A003

# LA QUINTA INN AND SUITES

## PALACE PARKWAY AT INTERSTATE HIGHWAY 30 GRAND PRAIRIE, TEXAS

This document is provided to clarify areas where proposed project is classified as deficient per the City of Grand Prairie Unified Development Code and Appendix F. Refer UDC and Appendix F. Analysis worksheet for further details.

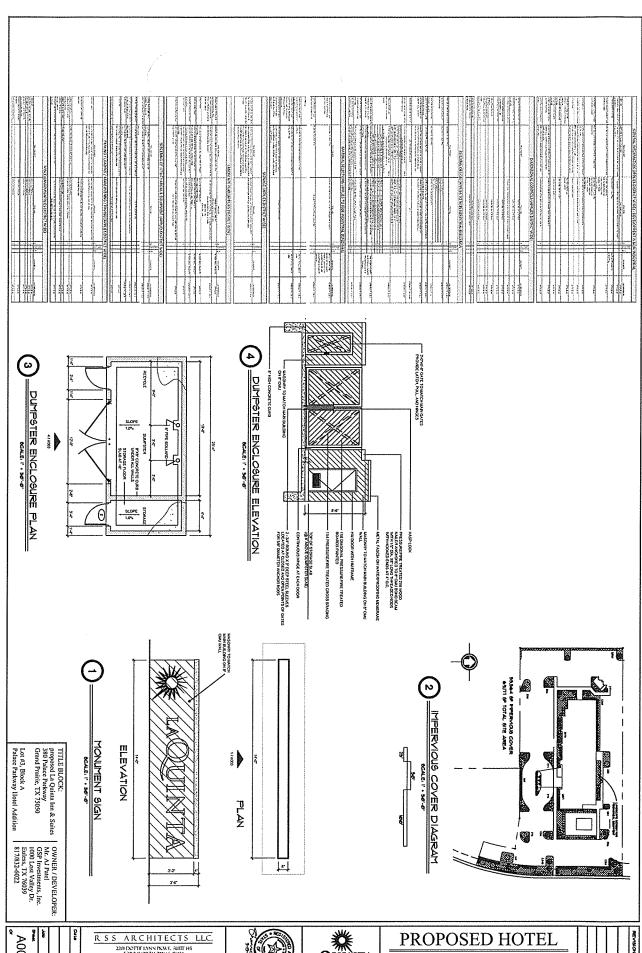
- Proposed Building Height
  - o RESPONSE: 25' Building Height is required, 64'-2" Building Height is provided.
- Horizontal Articulation of Primary Façade.

- RESPONSE: It is not possible to meet the requirements on the side facades due to building length.
- Vertical Roofline Articulation of Primary Façade(deficient on North side only)

- RESPONSE: Vertical roofline articulation requirements are met on all but North side of building.
- Cornice Element at Parapet
  - o RESPONSE: Main roof parapet cornice exceeds requirement (required 18", provided 30"). Some sections of lower roof parapet cornice have 10" in lieu of required 18".

- Indicate Windows and Covered Walkways are Provided
  - o RESPONSE: Covered walkways are not provided. Windows are less than required 25% on all elevations. Windows requirement cannot be met, as this is a residential use at the guest rooms. The 25% is exceeded at the public areas (breakfast room, lobby, etc...).

- Indicate Roof Profile Component (Curvilinear, Domed, Arched, Two or More Sloped Planes)
  - o RESPONSE: Roof profile component as described is not provided.

- Indicate Amount and Location for the 25% Supplemental Stone Requirement
  - o RESPONSE: There is no stone used for this project.

- 30' Landscape Buffer at Public Street(s)
  - RESPONSE: 30' buffer required along Palace Parkway, but 16' buffer is provided. This
    aligns with existing development along Palace Parkway. Site landscaping area exceeds
    requirements by 4 times.
